Land Development & Transportation Committee
Staff Report
April 12, 2018

Case No:	17ZONE1017
Project Name:	Circle K
Location:	9201 Preston Hwy
Owner(s):	Scott Whitaker
Applicant:	Mac's Convenience Stores, LLC
Representative(s):	Bardenwerper, Talbott & Roberts, PLLC
Jurisdiction:	Louisville Metro
Council District:	24 – Madonna Flood
Case Manager:	Laura Mattingly, AICP, Planner II

Change in Zoning Pre-Application Staff Report

Planning Commission
Staff Report
July 30, 2018

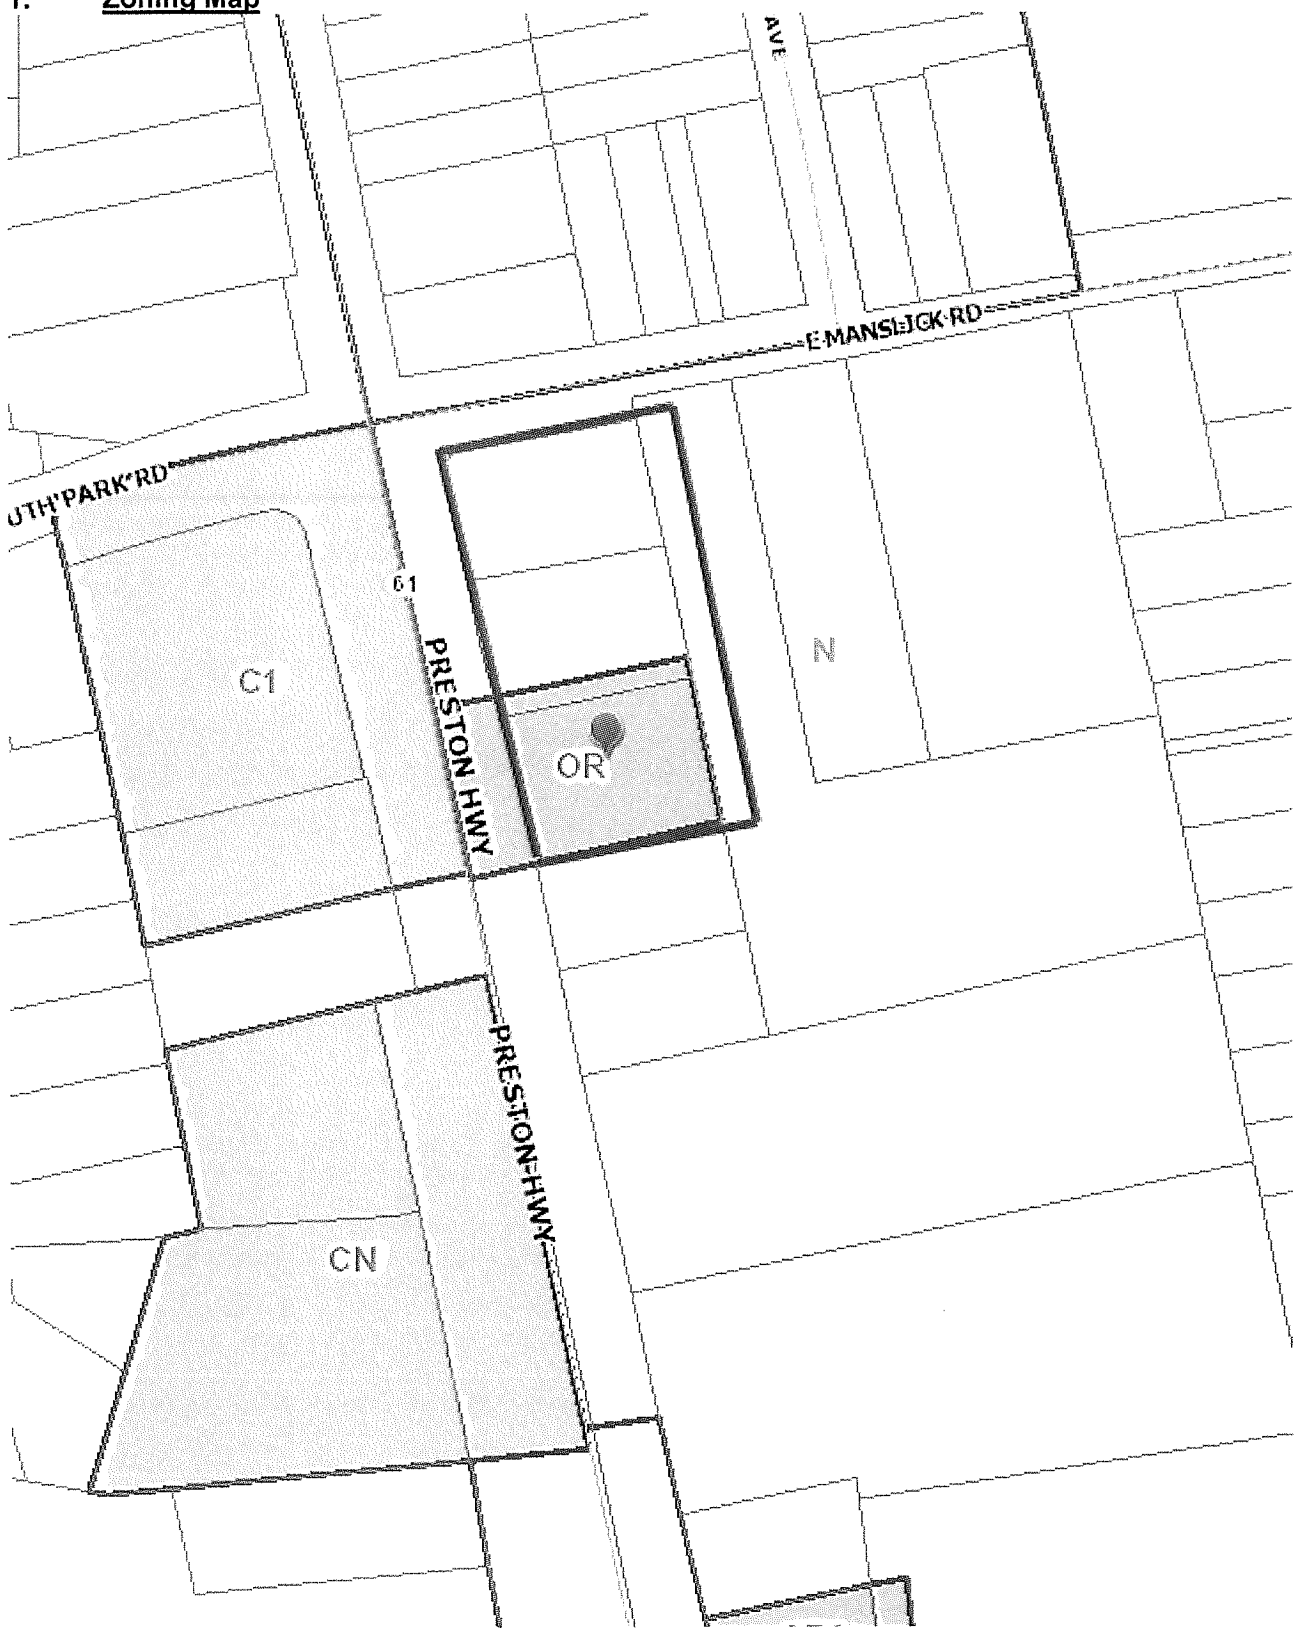
• Bike rack • Ped connect on Manslick

- The applicant needs to remove the pavement on the plan and add a note that future connectivity will be made upon redevelopment of the adjacent site.
- MSD and Transportation have given preliminary approvals
